Models Affected:
Linea - ALL
FB-70 - ALL

TECHNICAL BULLETIN #34

December 16, 2003

Antidisturbance Filter

P/N L201 Electromagnetic Compatibility Filter, 470N+100R

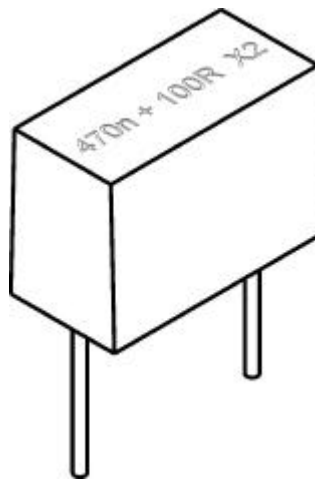
La Marzocco has discovered that in certain installations, the La Marzocco espresso machine can create electrical disturbance in the radio frequency bandwidth. This may be resolved by adding a capacitance/resistance anti-disturbance filter (p/n L201 Electromagnetic Compatibility Filter, 470N+100R). The filter must be installed in parallel with the coil of the contactor switching the steam boiler heating element. This can be accomplished either by installing the filter directly on the contactor or by installing the filter on the main electrical terminal block.
